Docket Nos. 50-269,50-270
and 50-287

SUBJECT: NUREG-0737 ITEMS II.K.3.1 - AUTOMATIC PORV ISOLATION AND
II.K.3.2 - REPORT ON PORVs FOR OCONEE NUCLEAR STATION

SAFETY EVALUATION BY THE OFFICE OF NUCLEAR REACTOR REGULATION
OF B&W LICENSEES' RESPONSES
TO NUREG-0737 ITEM II.K.3.2

Figure 5. Overpressure Events - Theoretical Calculation Based on Normal Distribution of Setpoints (Block Valves Open)

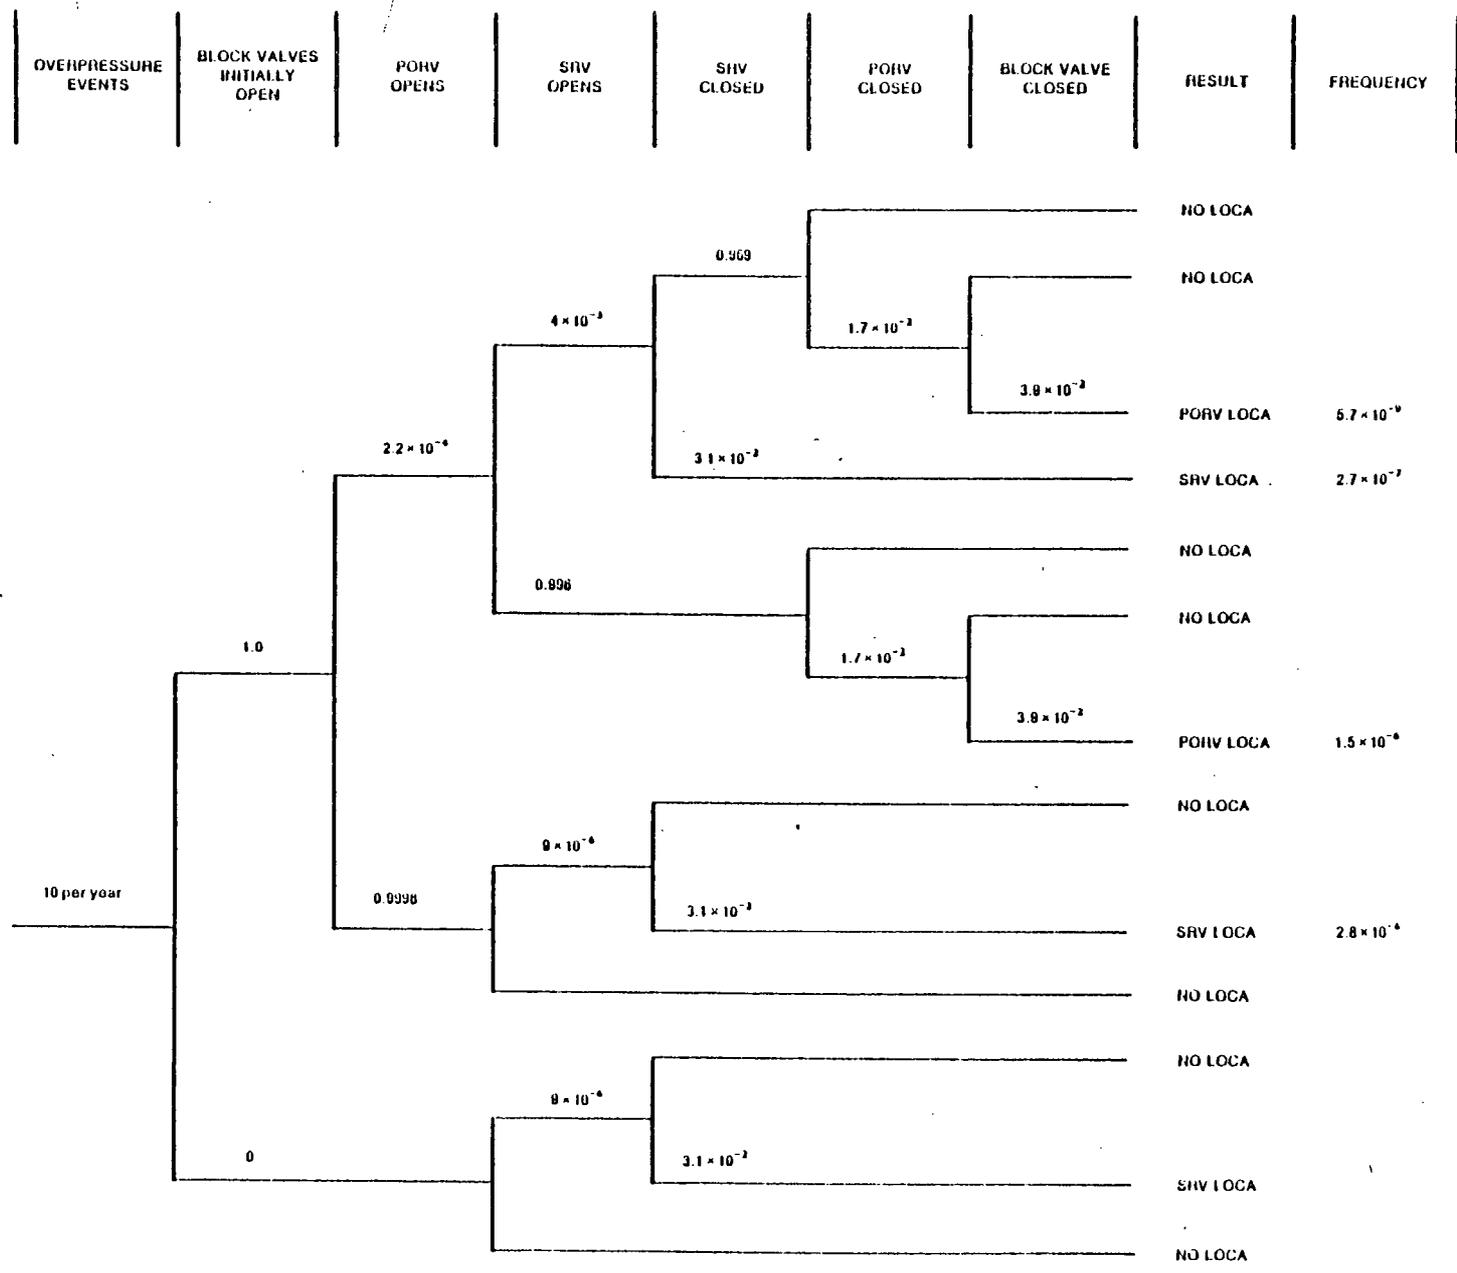
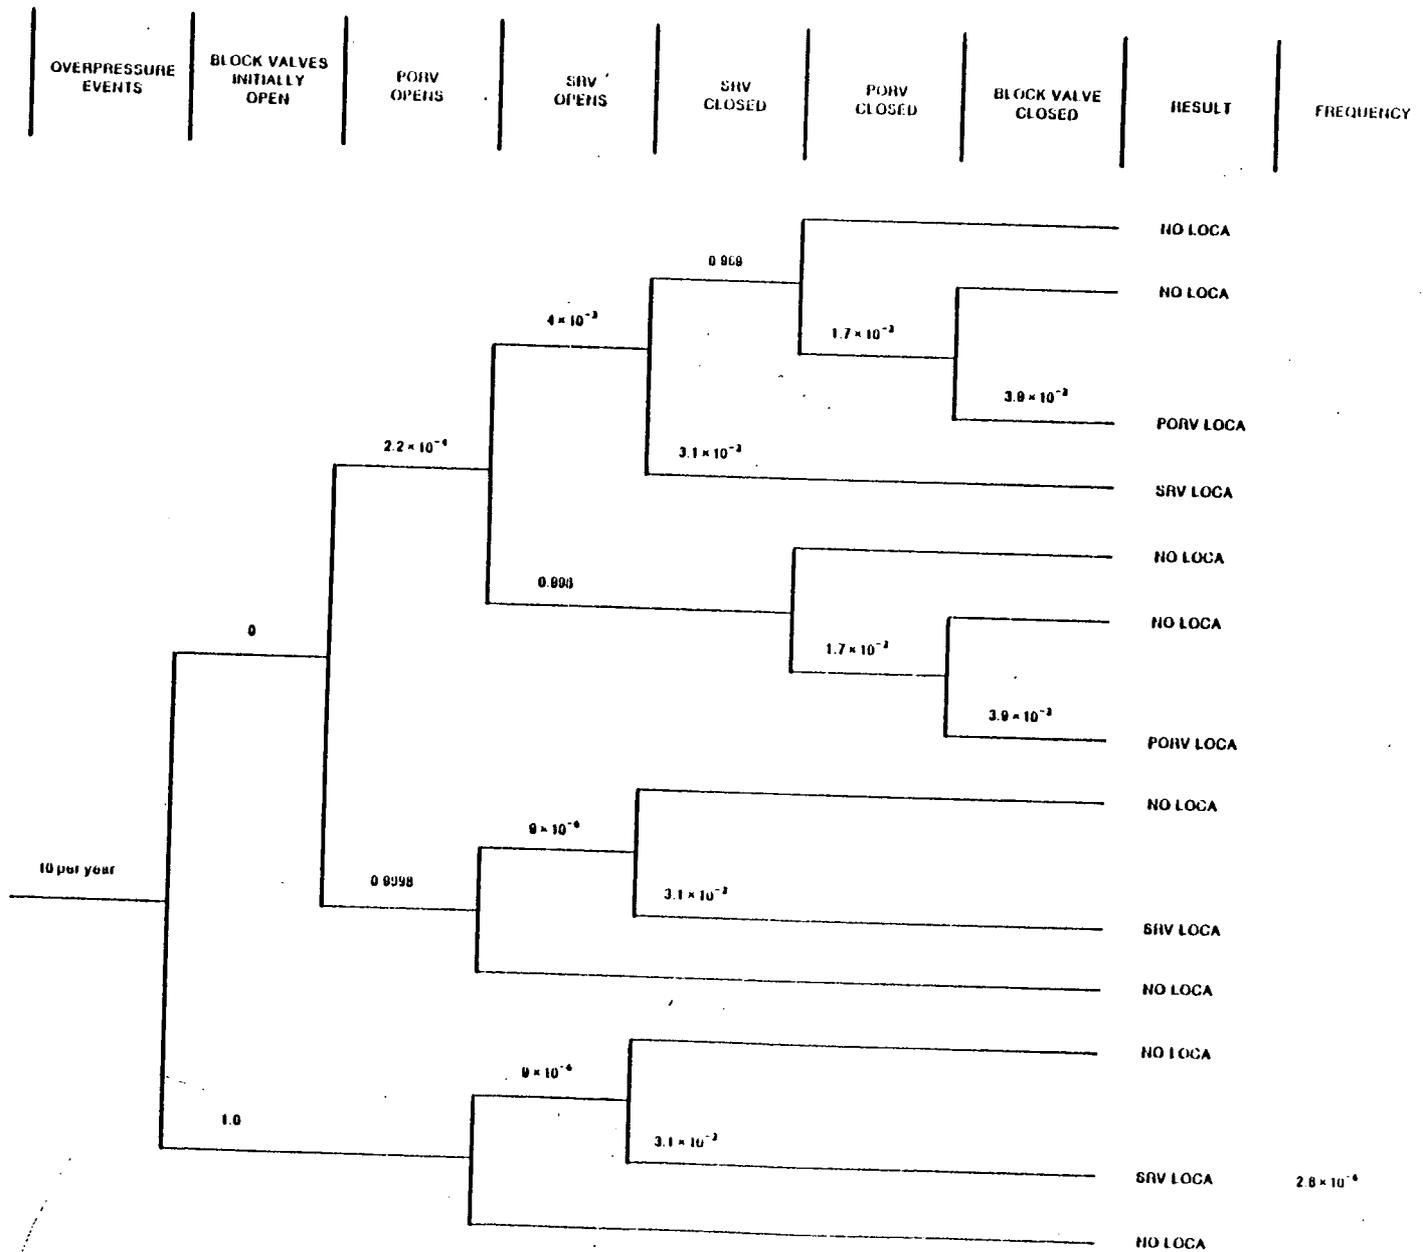
<u>Block Valves 100% Open (Figure 5)</u>	<u>Block Valves 100% Closed (Figure 6)</u>
Stuck-open PORV per rx-yr	1.5×10^{-6}	Not applicable
Stuck-open SRV per rx-yr	3.1×10^{-6}	2.8×10^{-6}

in the RCS system, this analysis shows that the probability is quite small and that it is amply bounded by the predictions of WASH-1400.

Figure 7. B&W Calculation - Davis-Besse

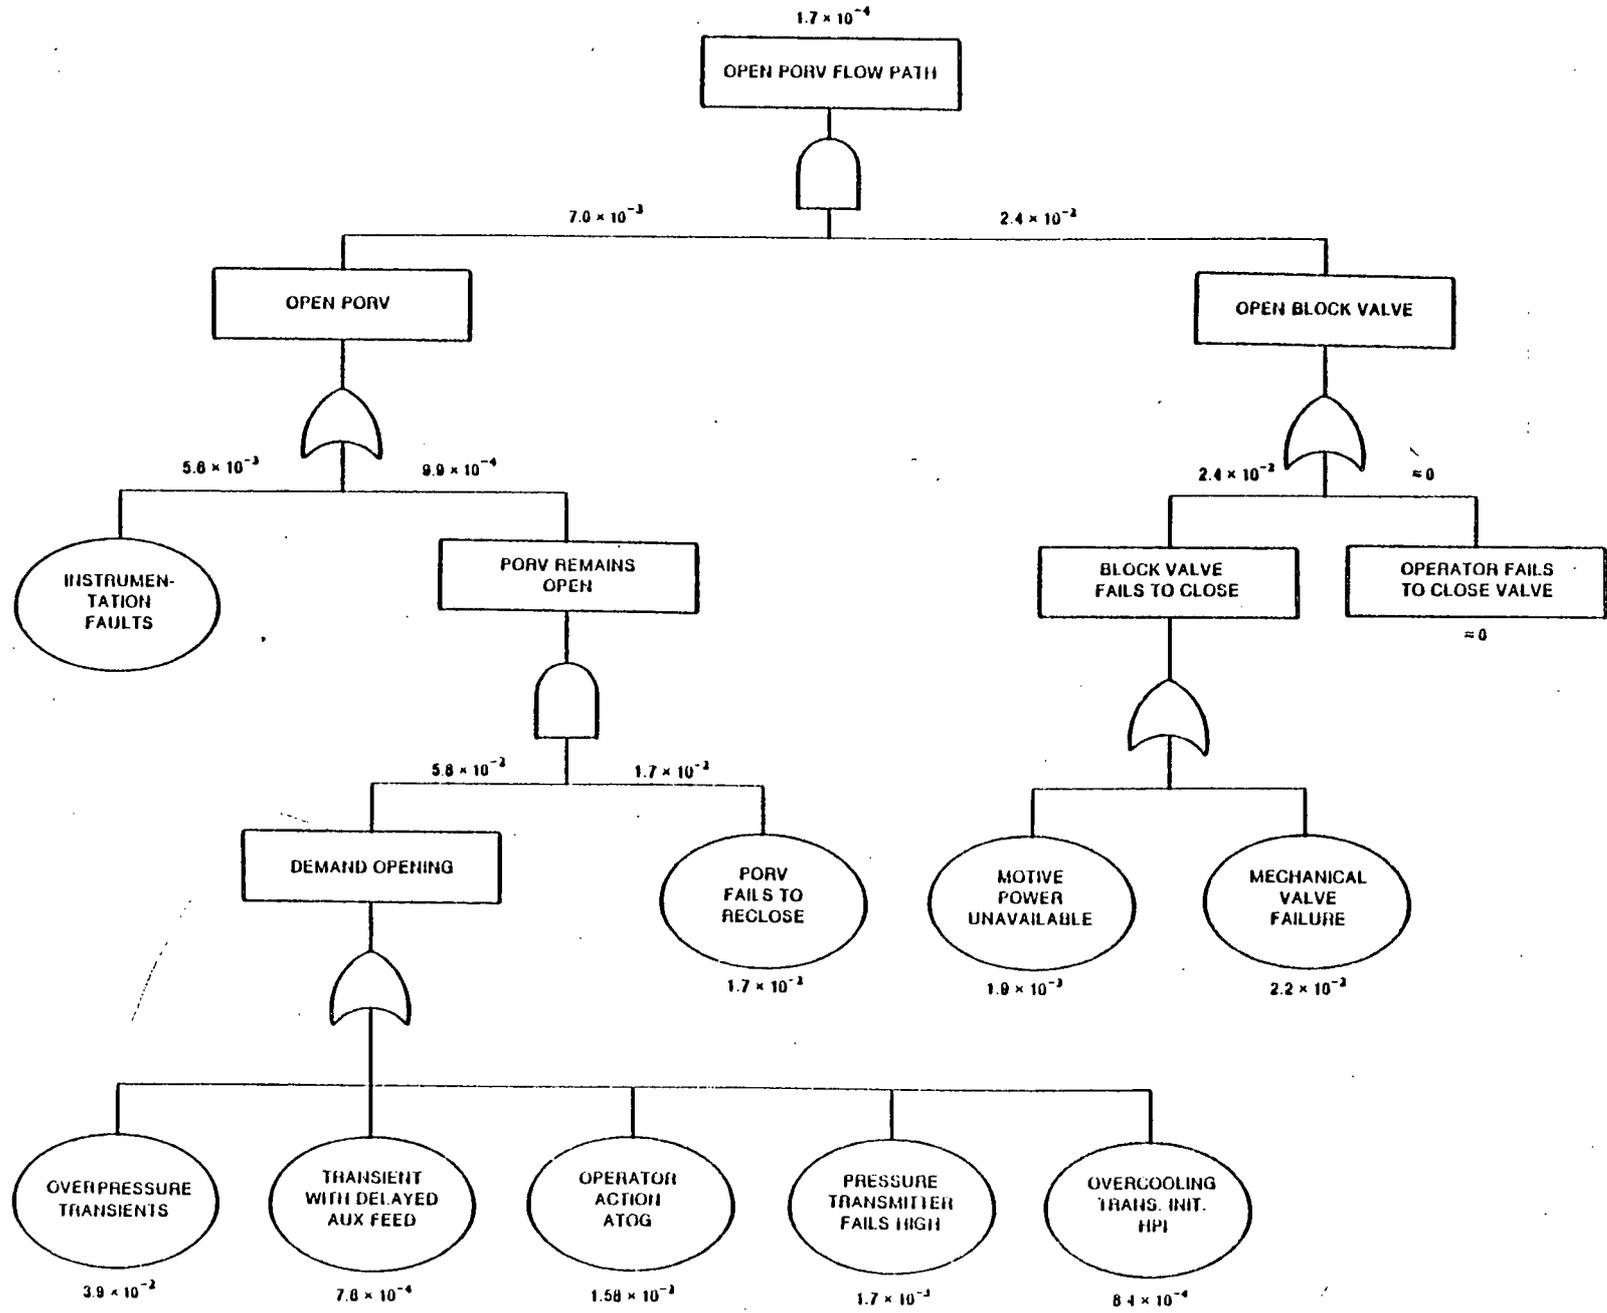
Using the Davis-Besse PORV opening rate of 5.8×10^{-2} per reactor-year, the calculation of Figure 1 of this report was repeated. The resulting probability of a small-break LOCA from a stuck-open PORV was as follows:

All B&W units except Davis-Besse Figure 1	Davis-Besse Figure 7
$1.4 \times 10^{-4}/\text{rx-yr}$	$1.7 \times 10^{-4}/\text{rx-yr}$

Figure 8. (Page 1) Revised Calculation - Davis-Besse

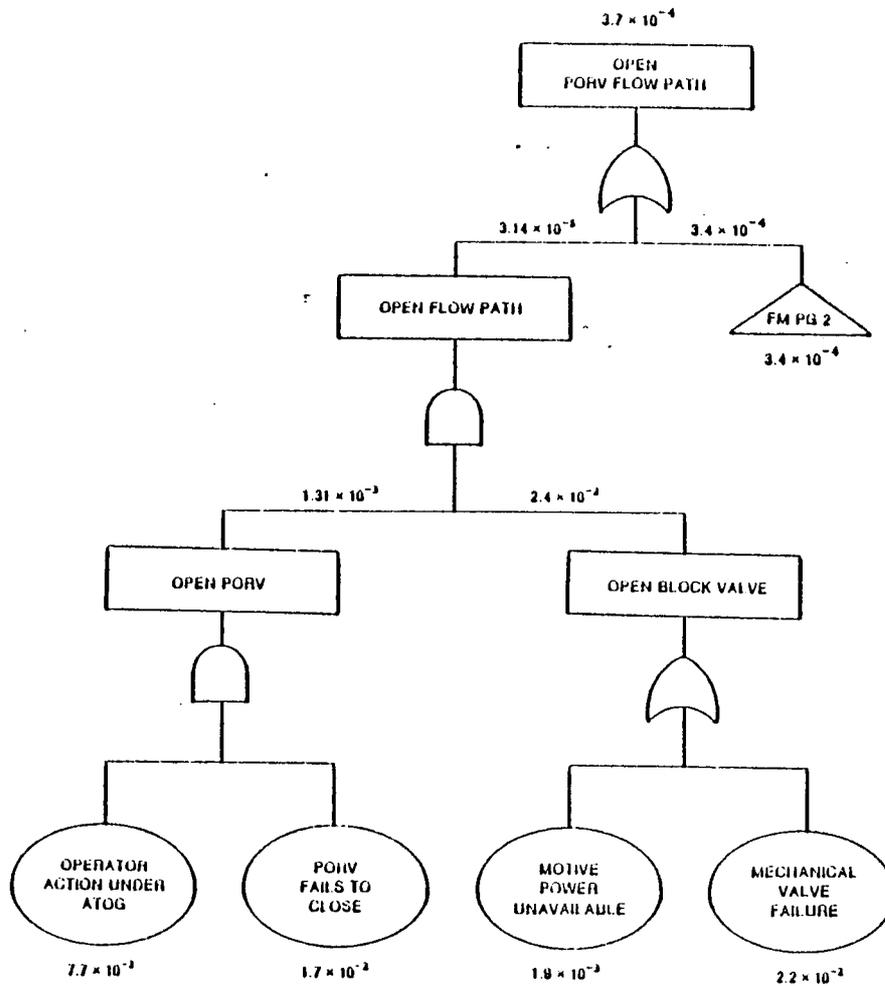
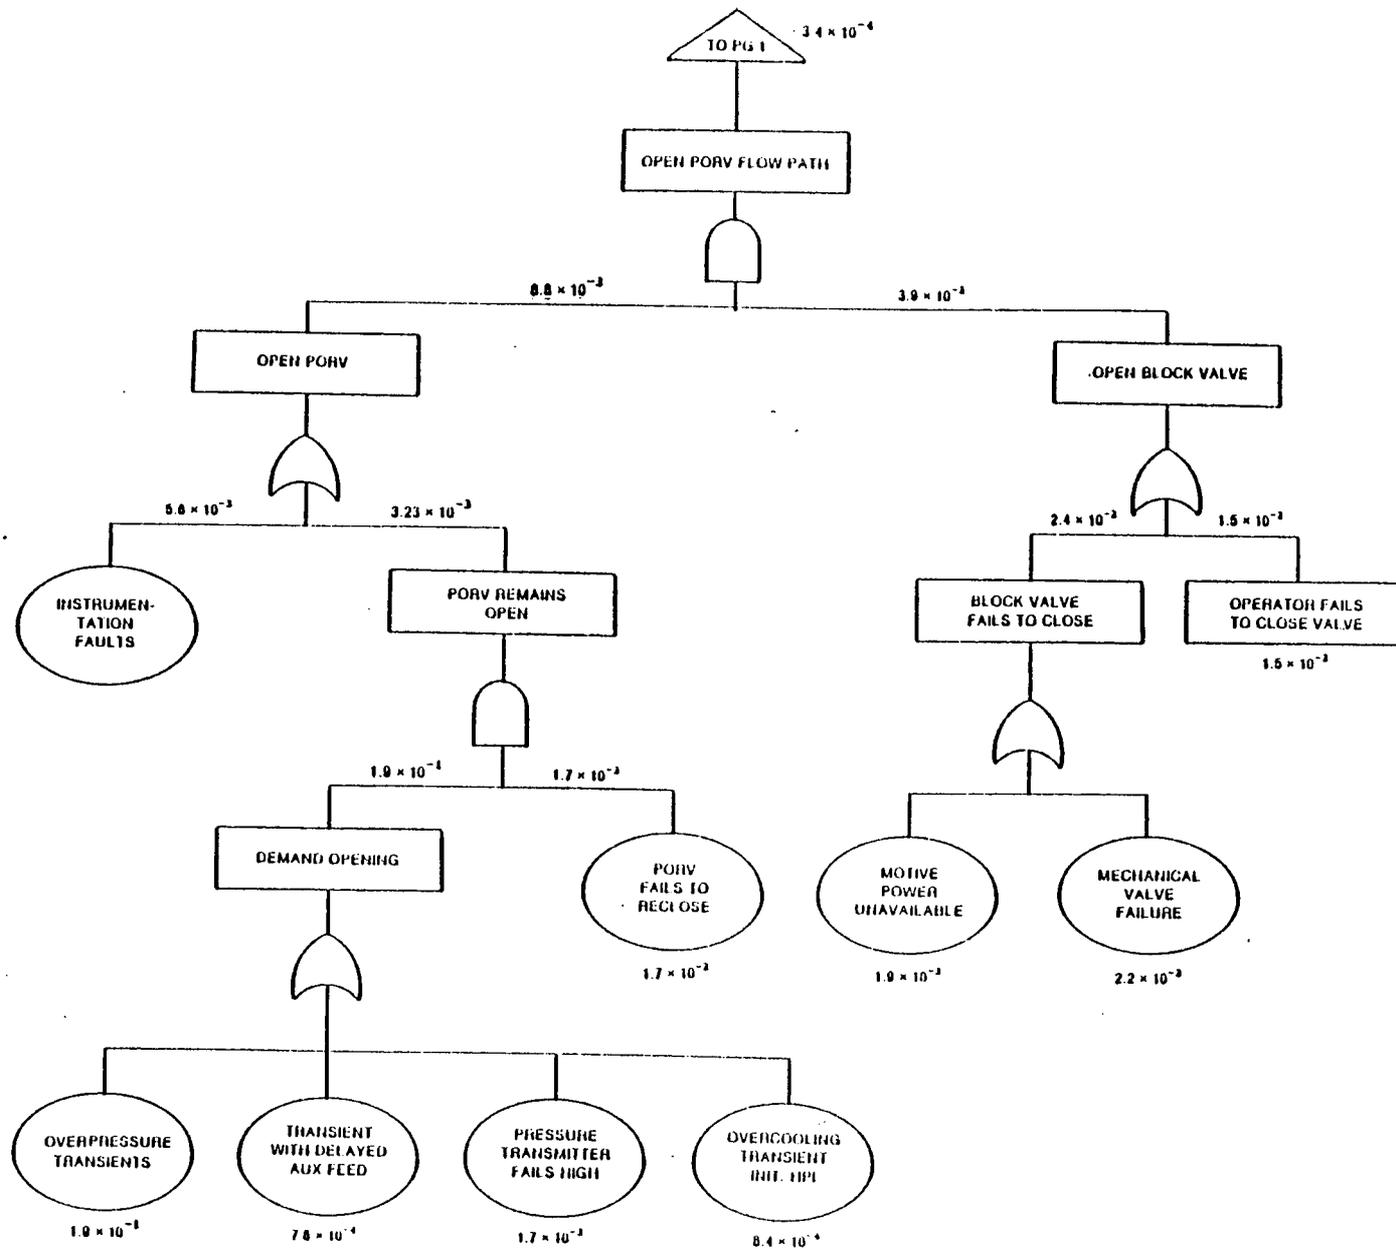
Next, the calculation shown in Figure 2 of this report was repeated for a unit with a PORV setpoint of 2400 psig (e.g., Davis-Besse). In this case, a reactor trip setpoint of 2300 psig with an overshoot of 27 psig and a standard deviation of 27.52 psig was compared with a PORV with a 2400 psig setpoint and a 21.7 psig standard deviation. The analysis showed that the PORV would open with a frequency of 1.9×10^{-2} per event, given an overpressure transient causing a reactor trip. This value was then inserted into Figure 2 and the resulting small-break LOCA probability was determined as follows:

As a result of these calculations, it can be concluded that, although the probability of a small-break LOCA from a stuck-open PORV at the Davis-Besse plant is greater than the same probability at the other B&W units, the difference is not significant and is probably less than a factor of 2 larger. Furthermore, since all values determined are less than the median WASH-1400 value for small-break LOCA from all causes of 1 x 10⁻³ per reactor-year, the B&W report can be considered applicable to all B&W units, whether the PORV setpoint is 2450 psig or 2400 psig.
